CREST VIEW SUBDIVISION, FIRST ADDITION,
RESUBDIVISION OF LOT 16, BLOCK A

APPLICATION NUMBER 1 DATE September 17, 2009
APPLICANT Crest View Subdivision, First Addition, Resubdivision of Lot 16, Block A
REQUEST Subdivision

DETAIL SITE PLAN

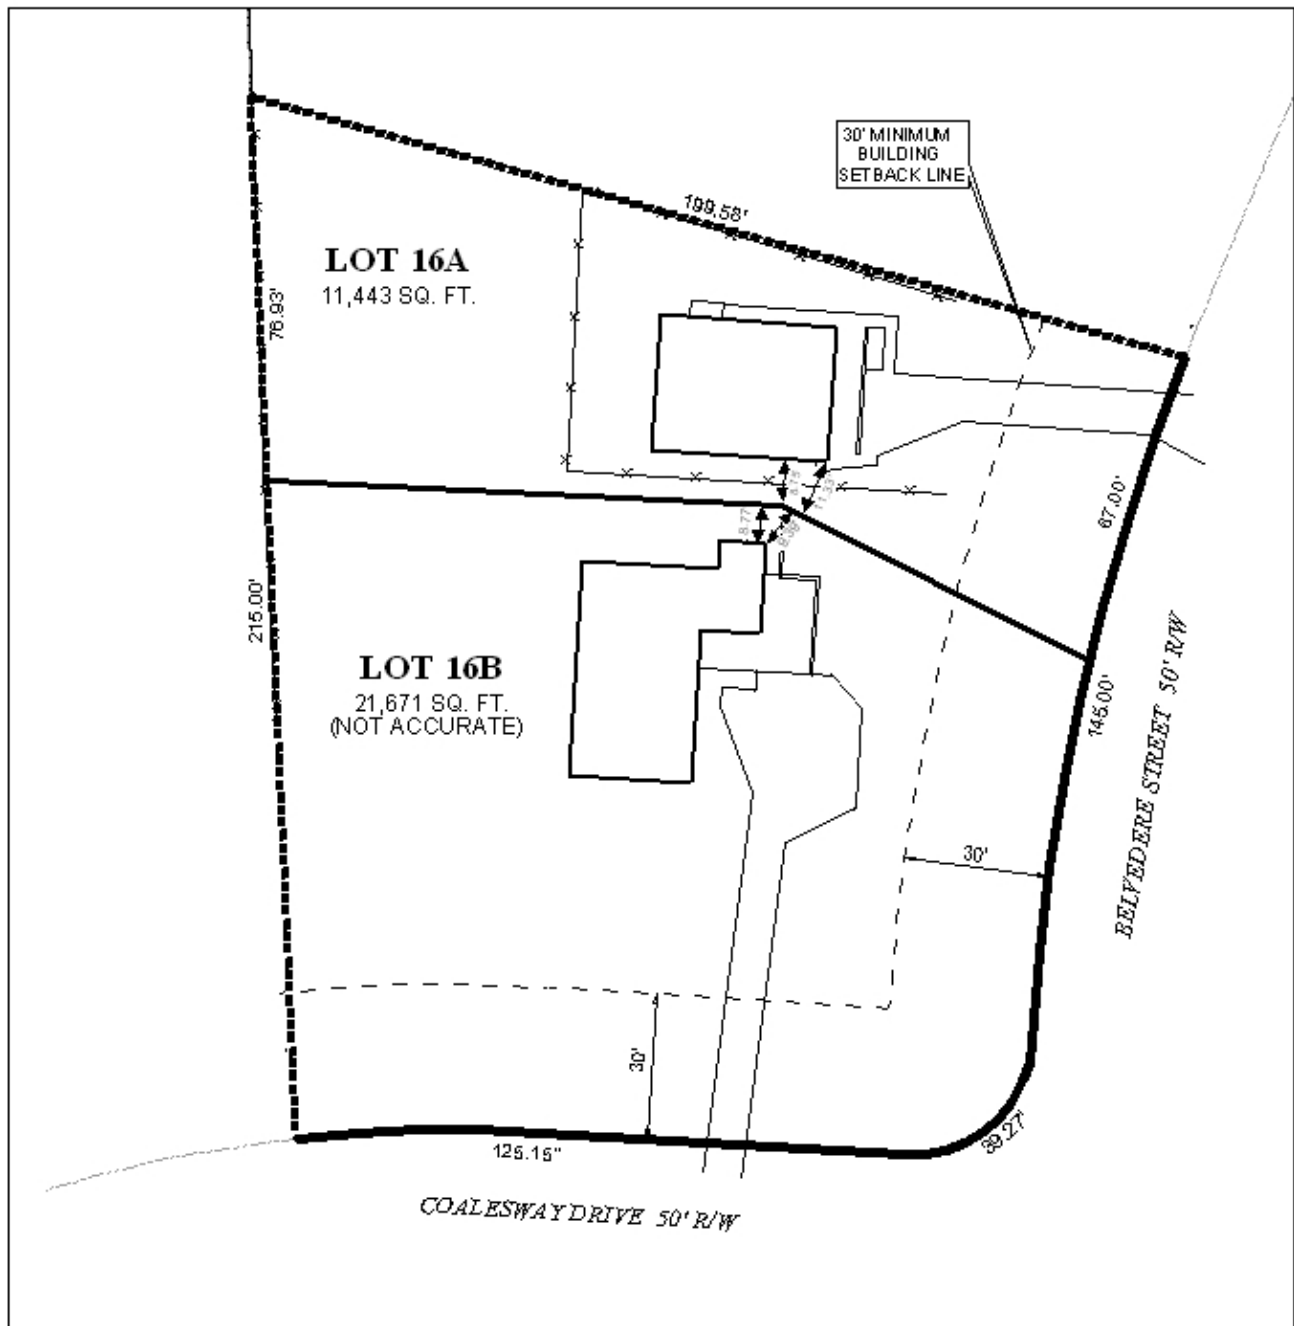
The applicant has chosen to apply for a subdivision; however, one of the proposed lots, specifically the one with the converted garage, does not meet the minimum public right-of-way frontage requirements as regulated by Section V.D.2 of the Subdivision Regulations. The lot is depicted with a 50-foot width at the 25-foot setback line along along Belvedere Street. The minimum required width for a lot is 60 feet at the minimum building line. The proposed lot area is indicated on the plat as 10,006 square feet which does meet the minimum lot area requirements.

structures, the structure located on the proposed Lot 16A (which is the converted garage) will not meet the setback requirements. A minimum side yard of 7.1 feet is required on a 50-foot wide lot; the plat is depicting a side yard of only 5.08 feet. The applicant has requested a side yard setback variance from the Board of Zoning Adjustment, which is scheduled to be heard at the July 6, 2009, Board of Zoning Adjustment meeting. It should be noted in this report that staff has an affidavit on file dated February 16, 2005 (when the separate electrical service for the garage was requested) from the property owner stating that the garage would not be used for residential or commercial purposes.

Lastly, the proposed Lot 16A is uncharacteristic in size and lot frontage for the area. The lot would be, by far, the smallest lot in area, and would have the smallest amount of public right-of-way frontage in the neighborhood. As such, it would seem that the proposed lot is not compatible or appropriate to the location of the subdivision and the type of development and use contemplated. Such compatibility and appropriateness are required by Section V.D.1 of the Subdivision Regulations.

The applicant has submitted a revised preliminary plat. The revised plat now indicates an 11,443 square-foot lot and a 21,671 square-foot lot. The plat also depicts both lots as being of adequate width to meet the standards of Section V.D.2 of the Subdivision Regulations. The new lot configuration also resolves the zoning violations that the old configuration created, namely a reduced side yard setback. Also depicted is a proposed 30-foot minimum building setback line.

It should be noted that there appears to be a discrepancy in the indicated lot size for the proposed Lot 16B. The original submittal indicated the lot with a size of 21,671 square feet. The new submittal indicates the lot being the same size as was indicated in the previous submittal, however, the size and dimensions of the lot have clearly changed. Thus, this should be corrected.

Further, the proposed lot that the converted garage will be on, proposed Lot 16A, will be vastly smaller and will have less street frontage than the other lots in this subdivision. Therefore, it would seem that the lot does not meet the standards of Section V.D.1 of the Subdivision Regulations which states, in part, "The size, width, depth, shape, and orientation of lots and the minimum building setback lines shall be compatible and appropriate to the location of the subdivision and the type of development and use contemplated." With that being stated, it would seem that this subdivision would be inappropriate.

- 1) Does not comply with Section V.D.2 of the Subdivision Regulations regarding minimum width;
- 2) Does not comply with Section V.D.1 of the Subdivision Regulations regarding compatibility and appropriateness;
- 3) The proposed subdivision would create a zoning violation.

- 1) Does not comply with Section V.D.1 of the Subdivision Regulations regarding compatibility and appropriateness.*
